APPENDIX H:

USACE PERMIT APPLICATION

PROJECT: Sitka Seaplane Base

SUBJECT: Section 408 Consultation

FIGURE 5: Marine Concept Alternatives

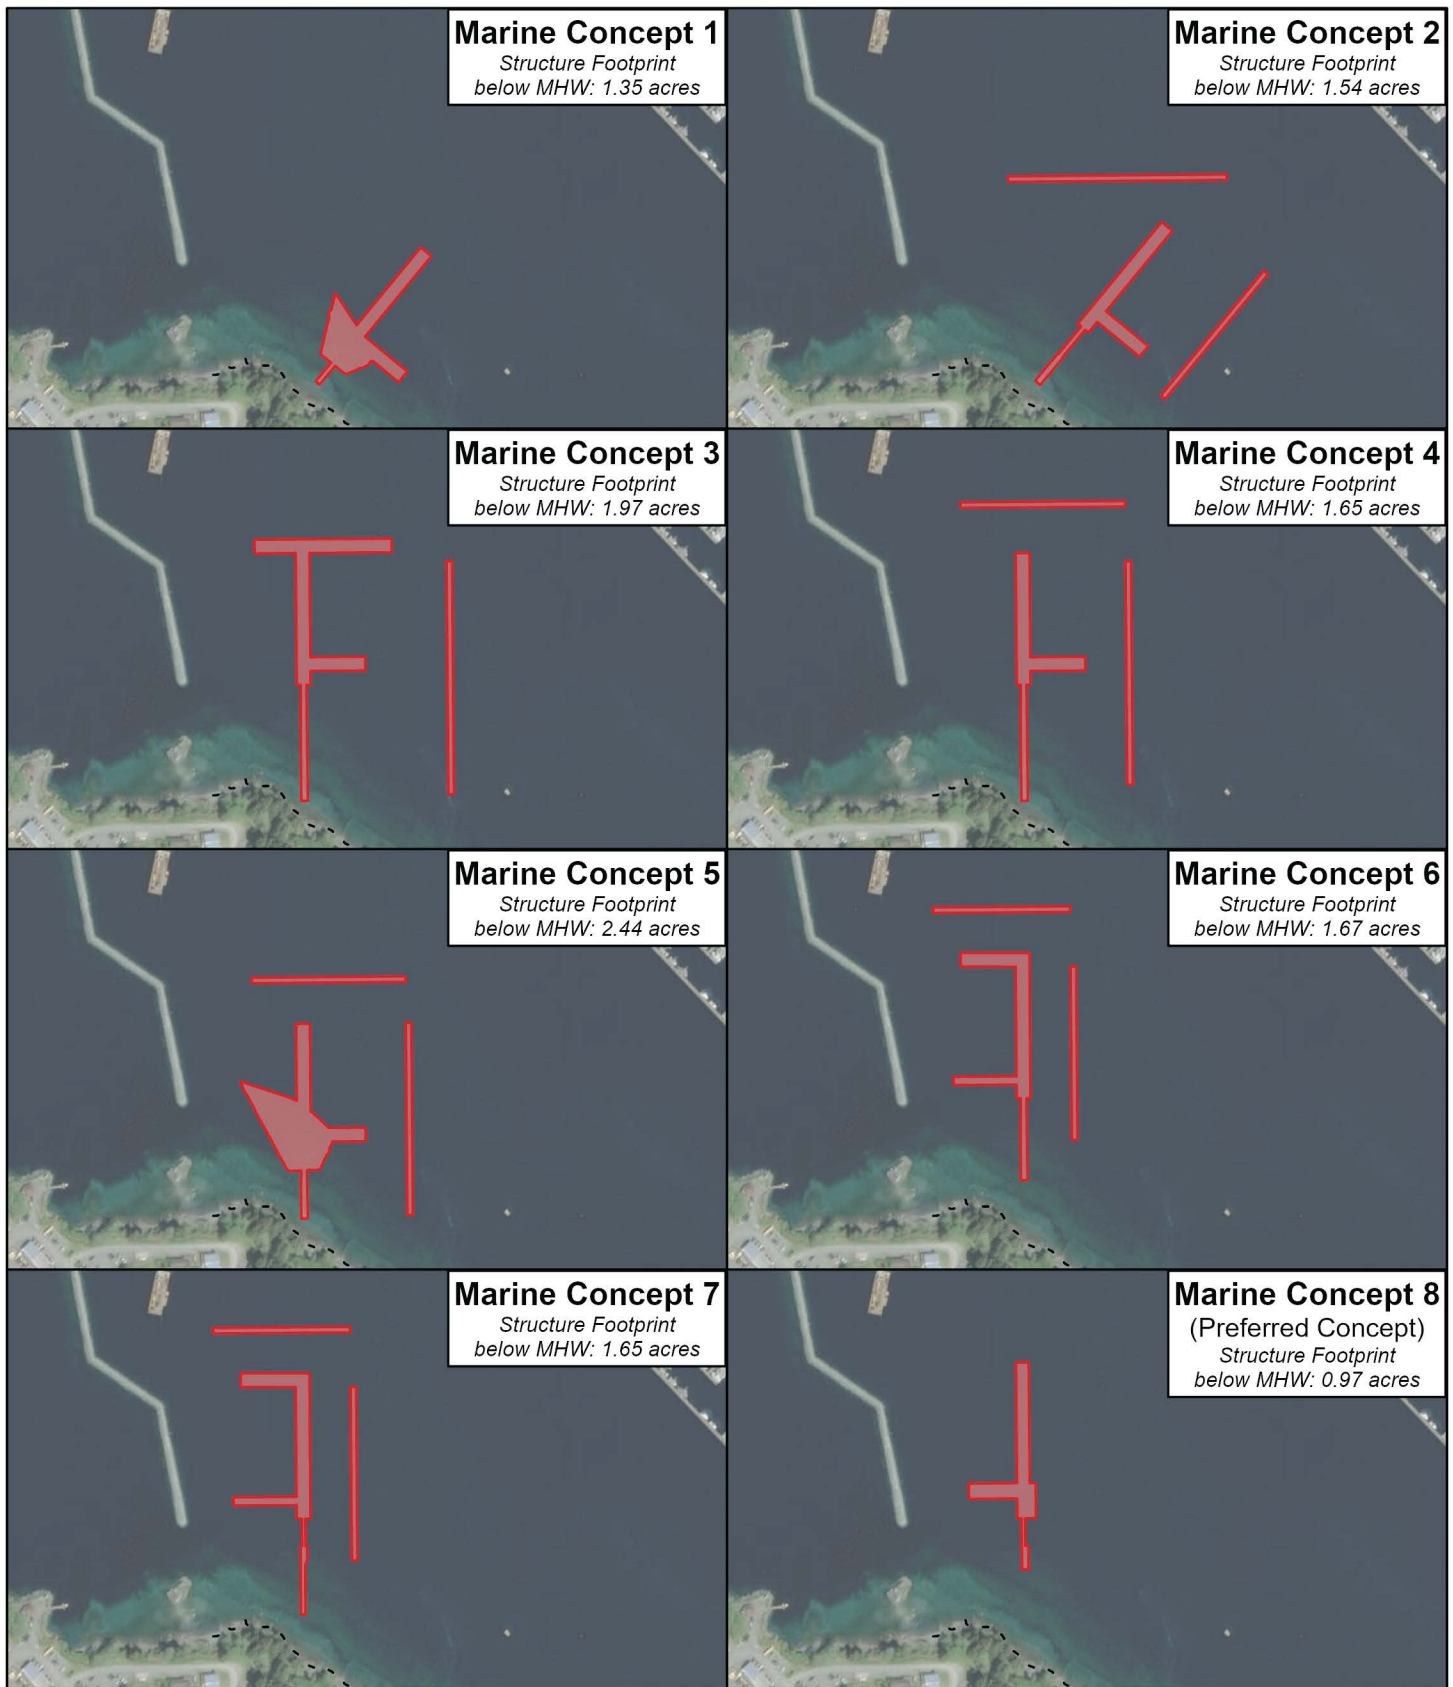
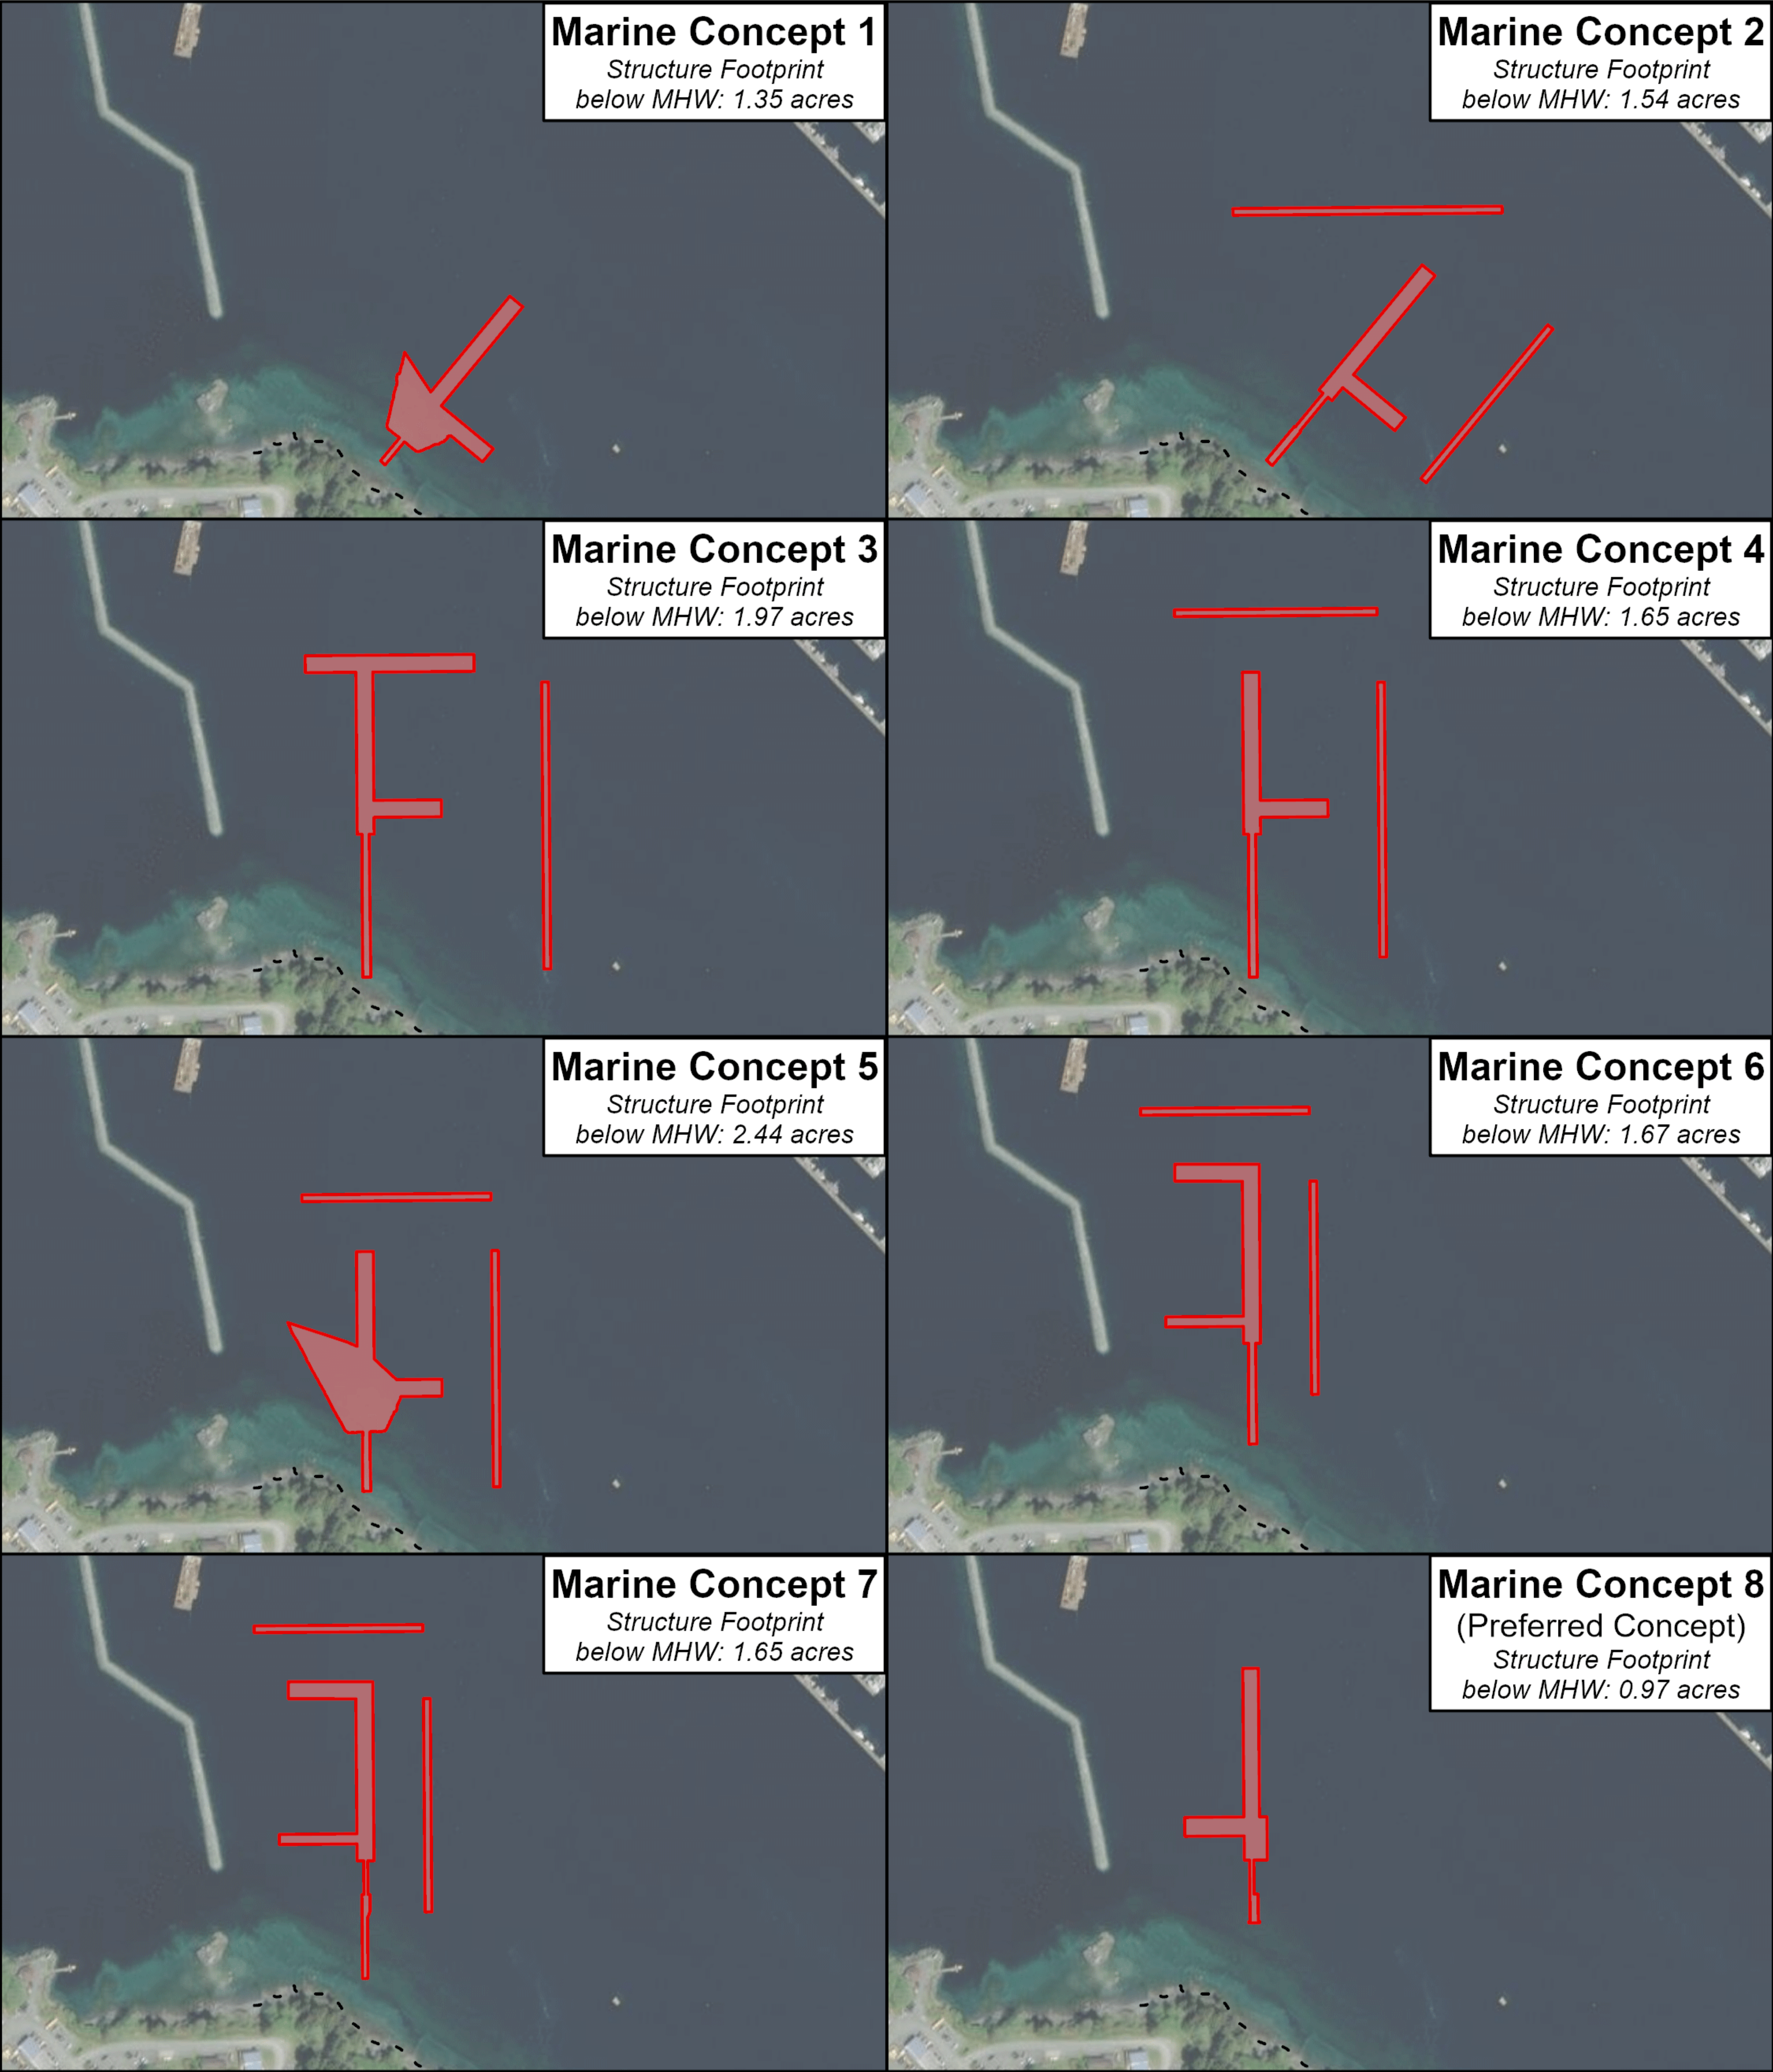
3/10/2025	USCG	Lot 15A-2 which the CG is in the process of purchasing from DEED, we should be closing later this month. It looks like the concept footprint depicted in Concepts A-F on pg. 16 of the POA-2023-00433 Sitka Harbor PN may be right up to the boundary of Lot 15A-2, but unable to verify just from the satellite images.	The project team is aware of the design as it currently stands being slightly over the lot line, however it will be changed once 65% design is initiated, along with a few other minor tweaks. So our final design will accommodate the boundaries by adjusting our cut/fill line and road placement and will not affect the Coast Guard's lotlines.	USCG: Thank you both for the quick responses. I really appreciate the discussion and coordination on this. Please let me know if there is anything else needed from my office.	March 11 to Moira Meek
